19ZONE1022

Kerrick Lane Rezoning

Louisville Metro Planning Commission

June 20, 2019

Applicant's Development Plan

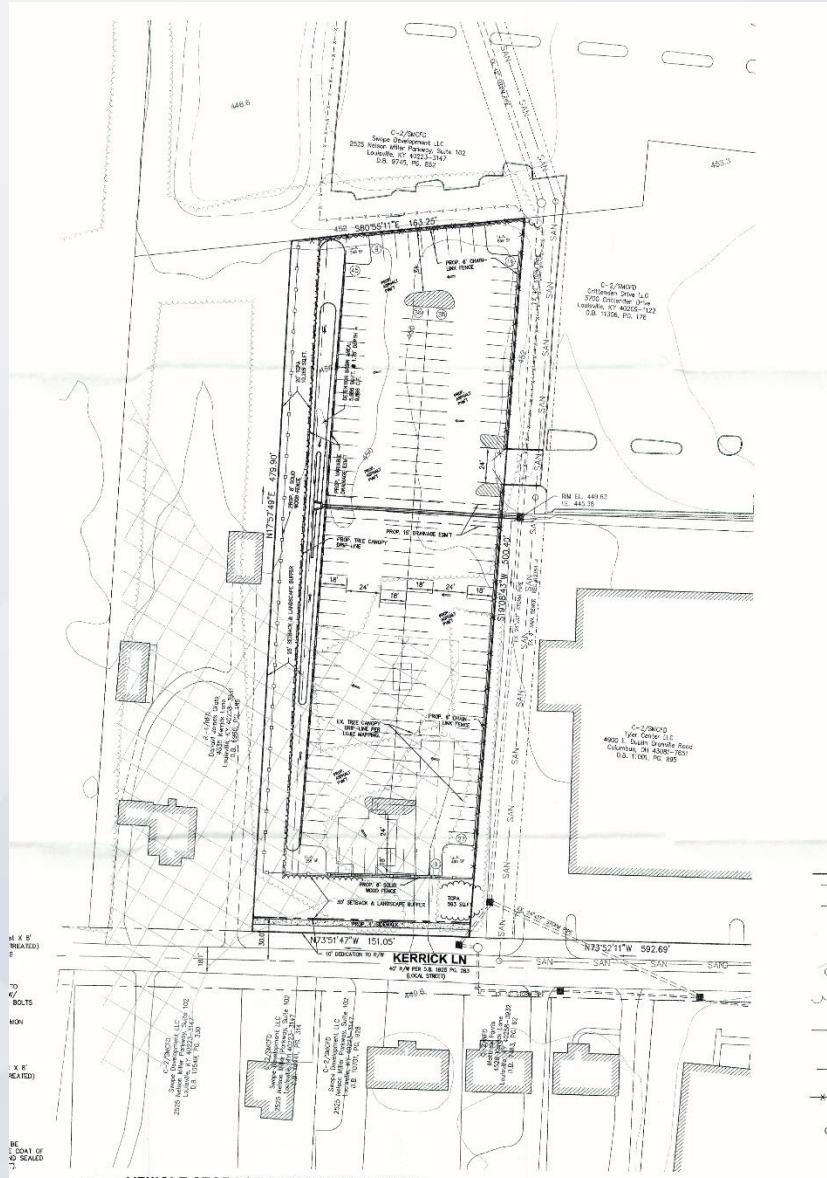
- The applicant proposes to change the form district of the site to Suburban Marketplace Corridor, which would be an appropriate form district for the proposed zoning district and use.
- Activity would be buffered by vegetative screening to the neighboring residential property and to Kerrick Lane.
- The site is adjacent to existing C-2.
